**City of Lino Lakes
Environmental Board Meeting
September 24, 2014
6:30 p.m.**

**ENVIRONMENTAL BOARD
AGENDA ITEM 5A**

PROJECT NAME: White Pine Senior Living

REQUEST: Rezoning to R-4, High Density Residential, Preliminary Plat Review, Conditional Use Permit for Nursing Home.

WATERMARK CONCEPT PLAN

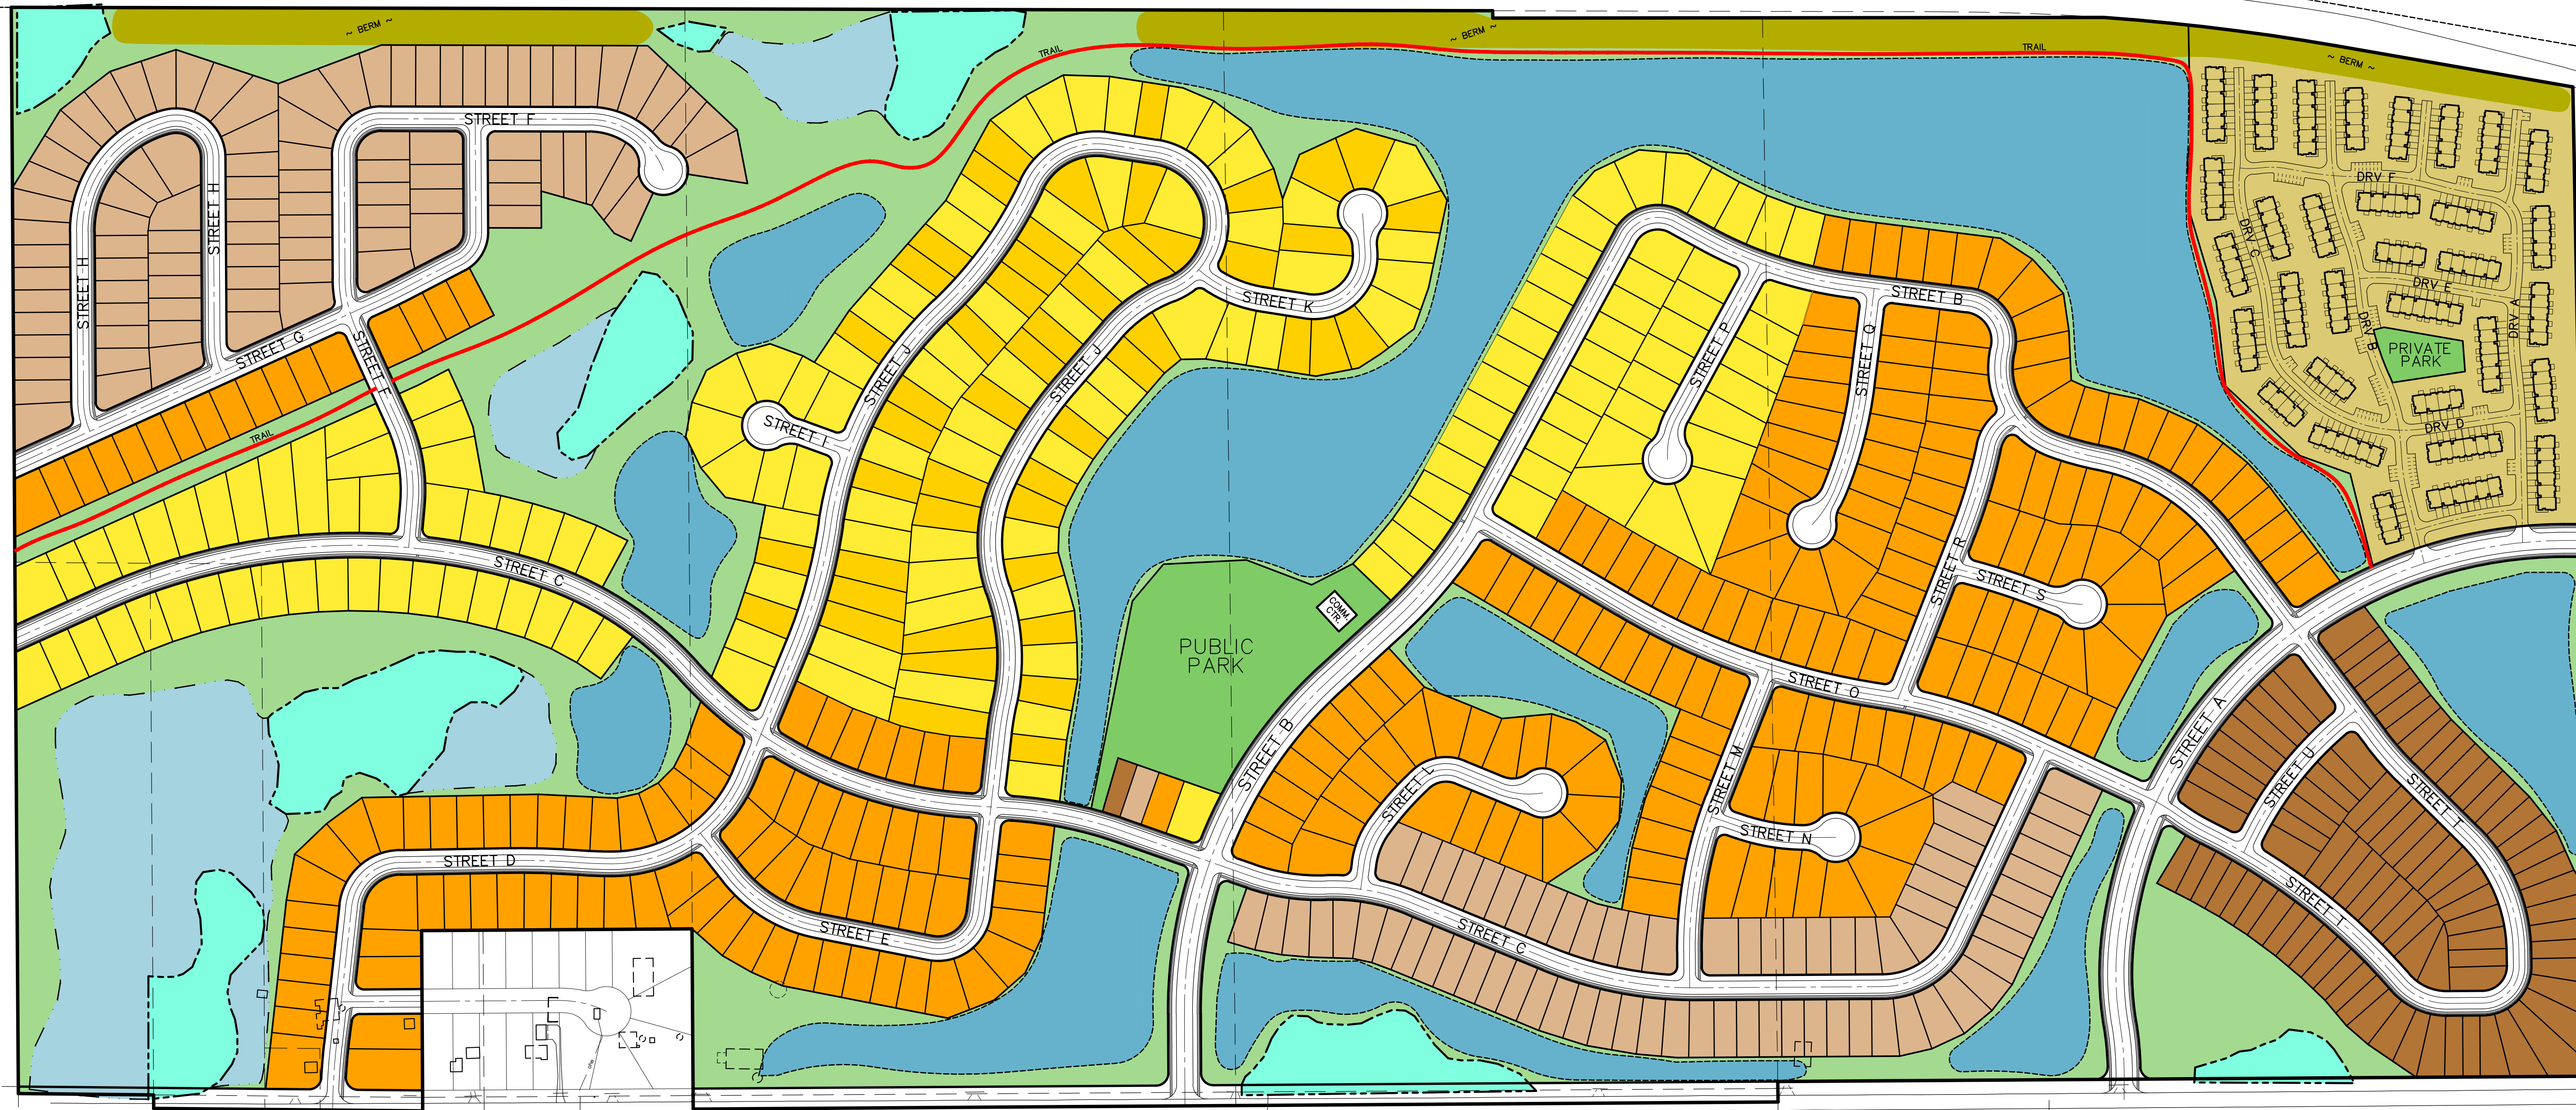
Corridor development to the south on the east side of the proposal, and along a proposed sound barrier (berm) should be enhanced to provide a more interesting meandering system on greenway with opportunities for tree plantings, and trail amenities such as benches. If possible, the proposed central park should be adjacent to the corridor and in tune with the Lino lakes Open Space and Trails and corridor plan. Increasing upland

The corridor development through the proposed Mattamy project will help as a corridor to mitigate potential impacts to ecologically sensitive areas. Implementing Conservation Design Framework of the AUAR is a requirement for this mitigation as well. Conservation design framework includes core and outlier habitat areas, buffering these natural resources, and providing for connectivity. A section on Ecologically Sensitive Resources in the AUAR should be addressed in detail for preliminary plat.

Greenway corridors should be extensively landscaped with abundant trees and native plantings in all surface water treatment areas. Native plant use is another element that could be used in the stormwater treatment train. The sound barrier berm as well as screening along 21st avenue, and boulevard trees must be adequately addressed with a landscape plan.

The Storm Water Pollution Prevention Plan must be written with specific reference to the site. The SWPPP must all aspects of the Construction Stormwater Permit requirements. Required site specific details must be included.

3. Design Stormwater management plan with a Treatment-Train approach.
4. Provide a noise Analysis.
5. Expand the Open Space Corridor to the south by creating meandering open space next to the earthen berm.

9. Submit landscape plans for screening the west edge, the open space areas, and the earthen berm.
10. Provide a SWPPP that is site specific and in conformance with the MPCA construction site permit requirements.

11. Investigate and map all private wells, weather operational or abandoned on the site.
12. Provide a street cross-section with detail for utilities, sidewalks, and boulevard trees.
